Access Compliance Report

Public Rights-of-Way

Intersection ID: N/A	Main Street: S_CALDWELL_ST	Cross Street: E_3RD_ST	Location: SW
ADA ID: DEC12F89896F	Ramp Type: BlendTrans1	Initial Pass/Fail: Fail	Overall Compliance: No
Severity Score: 12.5			
Codes/Mitigation Info/Possible Solution		Field Measurements/Component Compliance

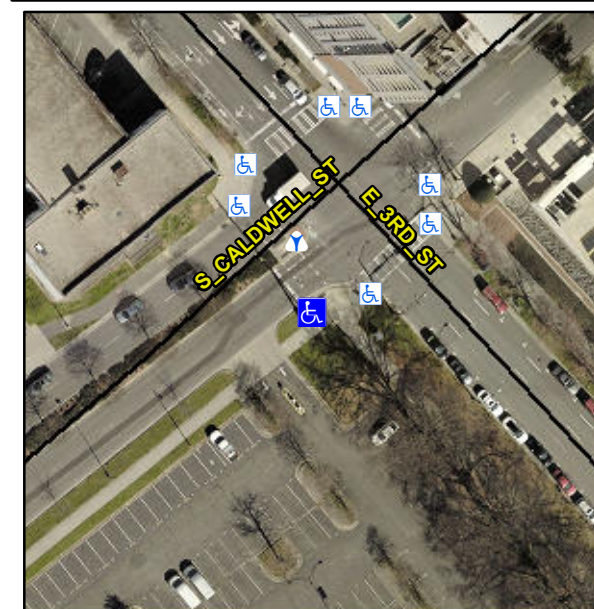
Not Found, R304.5.3

Compliance	Description	Data	Compliance	Description	Data
N/A	Ramp Length (in)	88.0	Yes	BlendTrans Slope (%)	2.4
Yes	Ramp Width (in)	51.0	No	BlendTrans XSlope (%)	5.6
N/A	Flare Type LT	N/A	N/A	Flare Type RT	N/A
N/A	Flare Slope LT (%)	N/A	N/A	Flare Slope RT (%)	N/A
N/A	Flare Traversable LT?	N/A	N/A	Flare Traversable RT?	N/A
N/A	Landing Length (in)	N/A	N/A	DWS Provided?	N/A
N/A	Landing Width (in)	N/A	N/A	DWS Contrast?	N/A
N/A	Landing Slope (%)	N/A	N/A	DWS Length (in)	N/A
N/A	Landing X Slope (%)	N/A	N/A	DWS Full Width?	N/A
N/A	Landing Curb? (Y/N)	N/A	N/A	DWS Offset (in)	N/A
N/A	Shared Landing?	N/A			
N/A	Gutter Ponding?	N/A	N/A	Gutter Slope (%)	N/A
N/A	Gutter Lip Ht (in)	N/A	N/A	Gutter X Slope (%)	N/A
N/A	Painted X Walk1?	Yes	N/A	Painted X Walk2?	N/A
	X Walk 1 Direction	To NW		X Walk 2 Direction	N/A
	X Walk 1 Width (in)	120.0		X Walk 2 Width (in)	N/A
	X Walk 1 Slope (%)	4.5		X Walk 2 Slope (%)	N/A
	X Walk 1 X Slope (%)	4.0		X Walk 2 X Slope (%)	N/A

N/A	Ramp inside XWalk1?	Yes	N/A	Ramp inside XWalk2?	N/A
	Road Slope (%)	4.0		Clear Space?	N/A
	Road X Slope (%)	4.5	N/A	Clear Space to XWalk (in)	N/A
N/A	Any Obstructions?	N/A	N/A	Storm Grate/Utility Hazard?	N/A
	Obstruction Type			Storm Grate/Utility Type	
		N/A			N/A
			Yes	Surface Condition? (G/P)	Good
			No	Curb Slope (%)	17.1

Remove & Replace Curb Ramp With Two New Directional Ramps or Equivalent.
